AURIX™ TC33x/TC32x errata sheet

Marking/Step: (E)ES-AA, AA

10594AERRA

Figure 1 Message buffer transfer from Message RAM to OBF

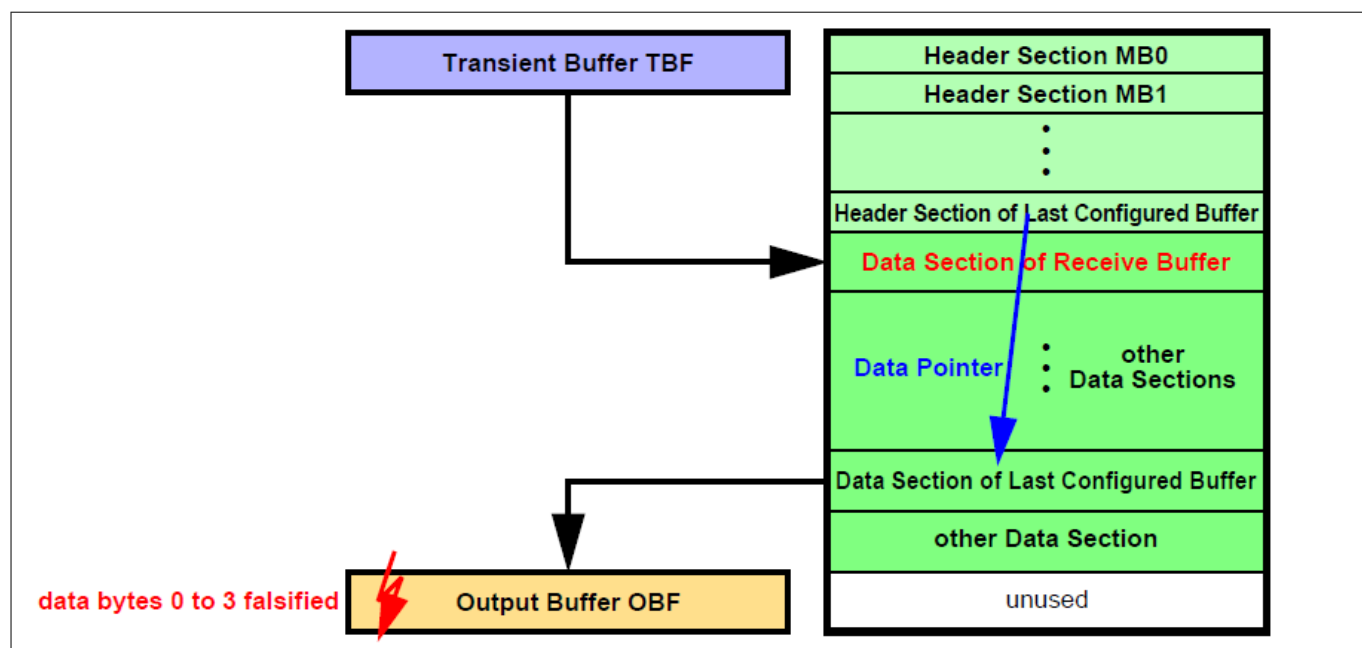
When the message buffer has its payload configured to maximum length (`PLC = 127`), the OBF word on address `00h` (payload data bytes 0 to 3) is overwritten with unexpected data at the end of the transfer.

a) When a message is transferred from the Last Configured Buffer in the Message RAM to the OBF and PLC = 127 it may happen, that at the end of the transfer the OBF word on address 00h (payload data bytes 0 to 3) is overwritten with unexpected data (see [Figure 1](#))

Figure 2 Message buffer transfer from IBF to Message RAM

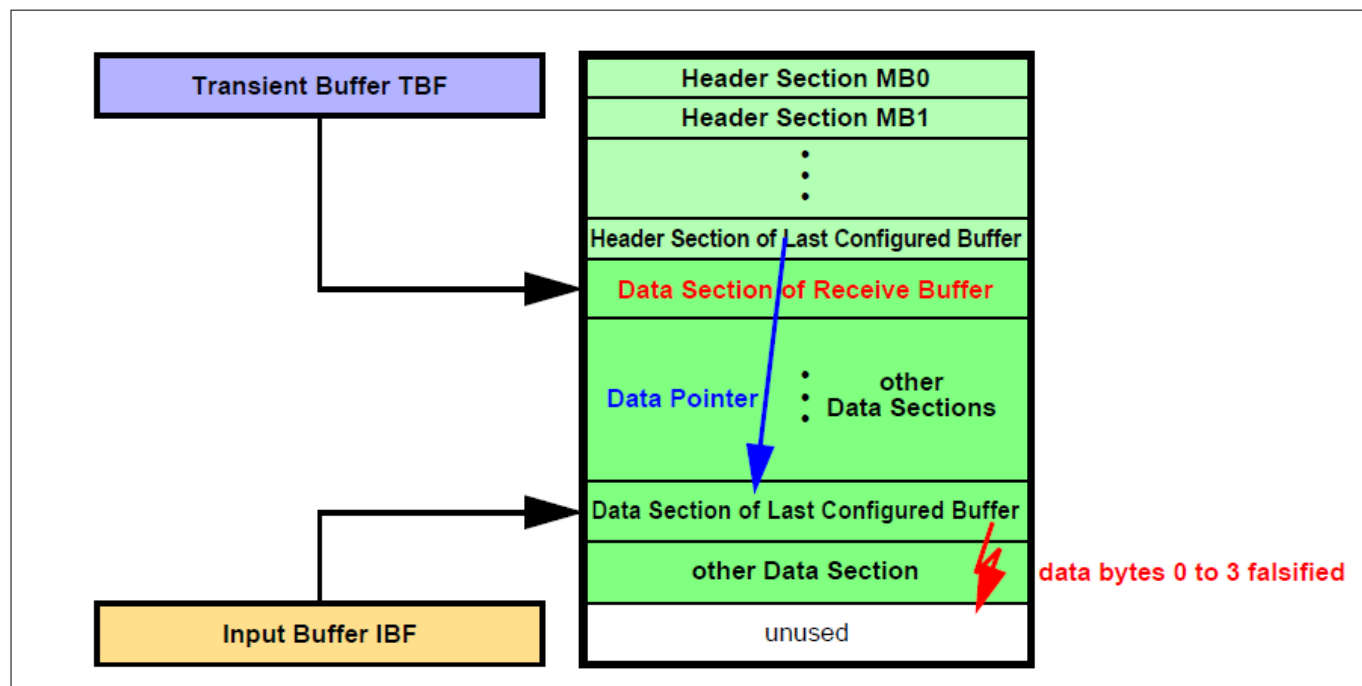
After the Data Section of the selected message buffer in the Message RAM has been written, one additional write access overwrites the following word in the Message RAM which might be the first word of the next Data Section.

b) When a message is transferred from IBF to the Last Configured Buffer in the Message RAM, it may happen, that at the end of the transfer of the Data Section one additional write access overwrites the following word, which may be the first word of another message's Data Section in the Message RAM (see [Figure 2](#))

Figure 3 Message RAM configurations

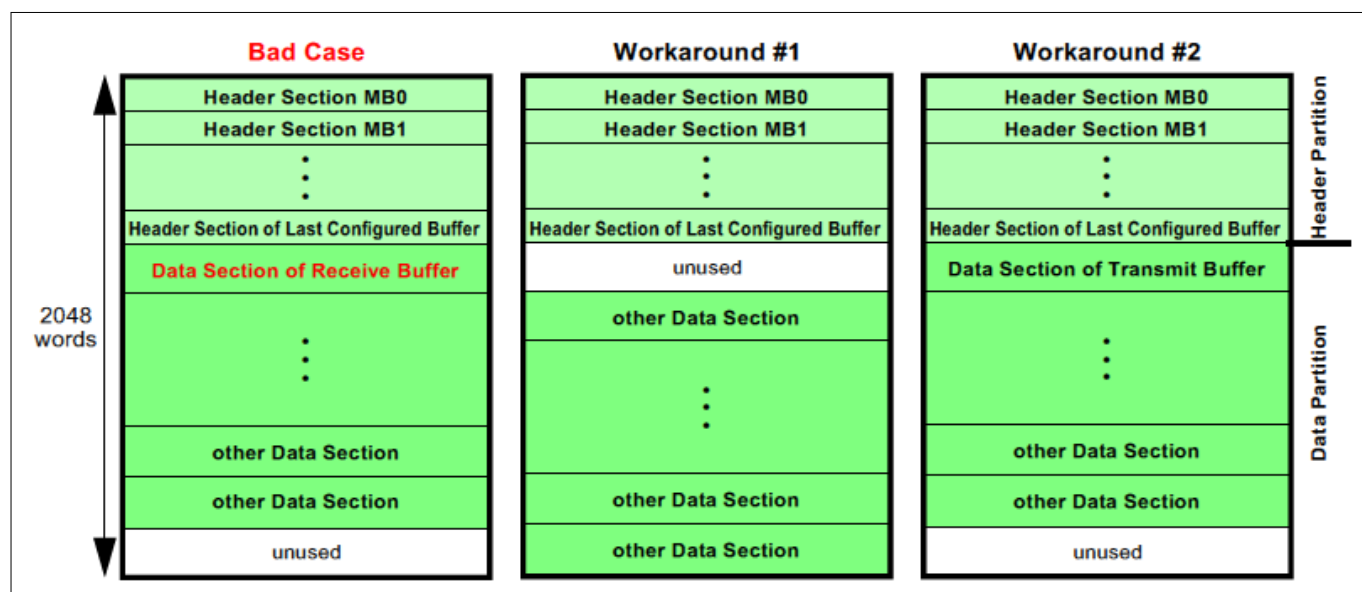
The erratum is limited to the case when (see [Figure 3](#) “Bad Case”):

Workaround 2

Ensure that the Data Section directly following the Header Partition is assigned to a transmit buffer.

Figure 8 Package Outlines TQFP-100 for TC33x/TC32x

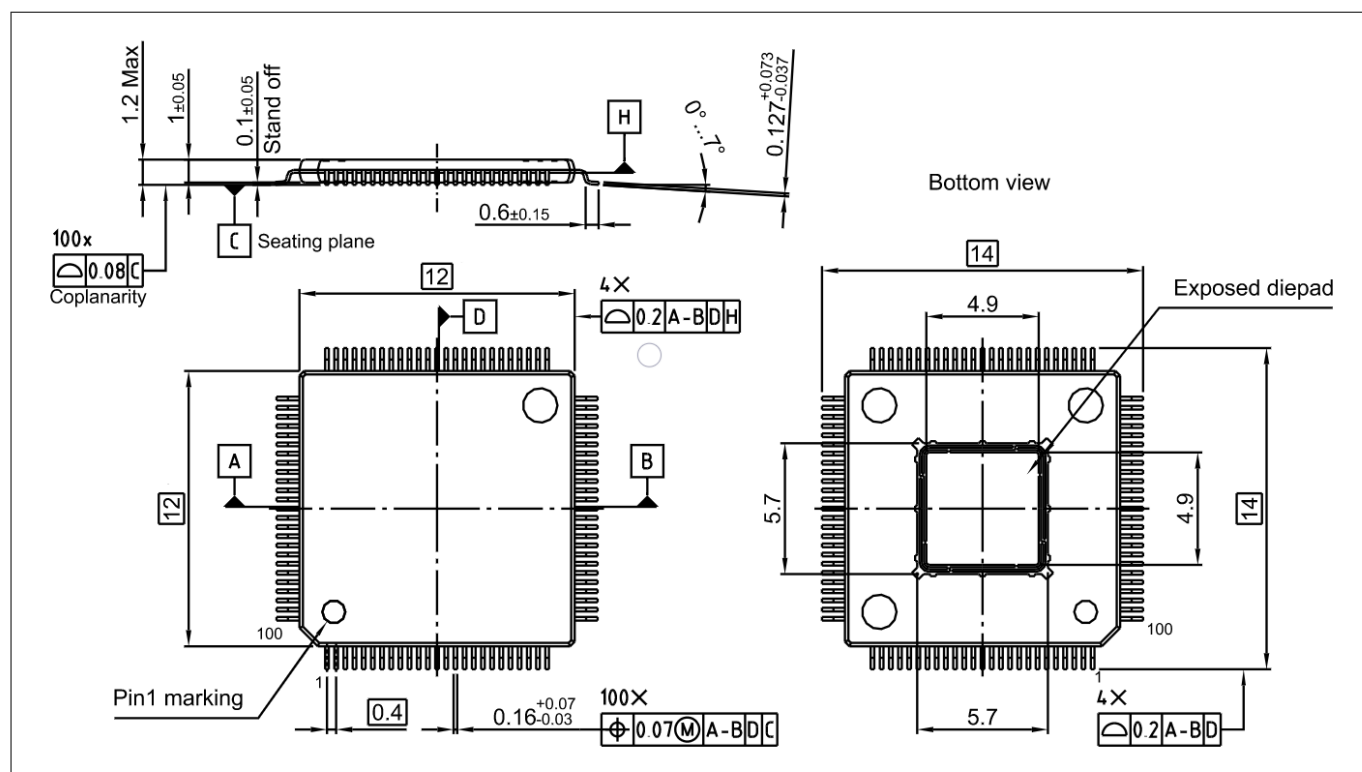
Note: For the exposed diepad of the TQFP-100 package of the TC33x/TC32x, structural corner protrusions have to be considered for purposes of system design and integration with a maximum boundary of 6.3 mm.

This information shall substitute the corresponding information in the TC33x/TC32x AA-step Data Sheet V1.1.

2.59 [GTM_AI.408] (A)TOM-RTL: Missing edge on output signal (A)TOM_OUT when CN0 is reset with force update event

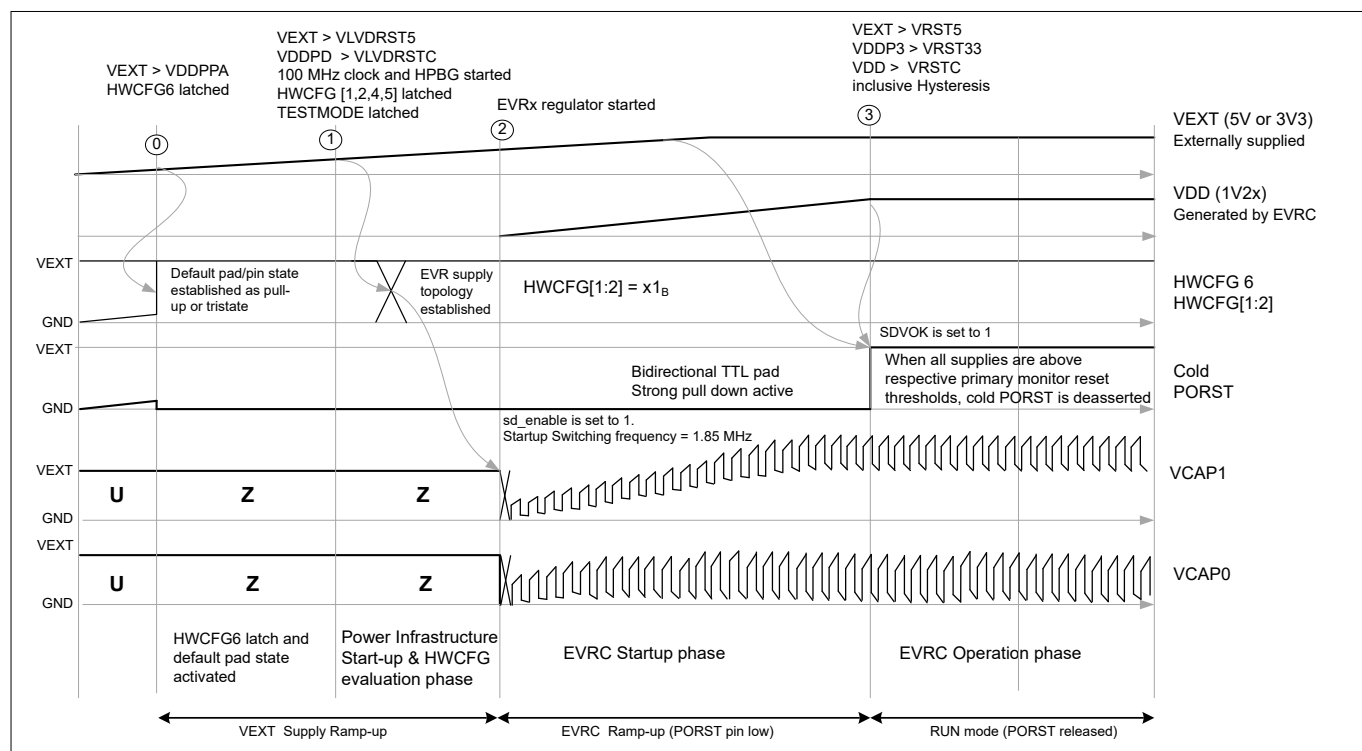
Documentation update

See corrected figures included below.
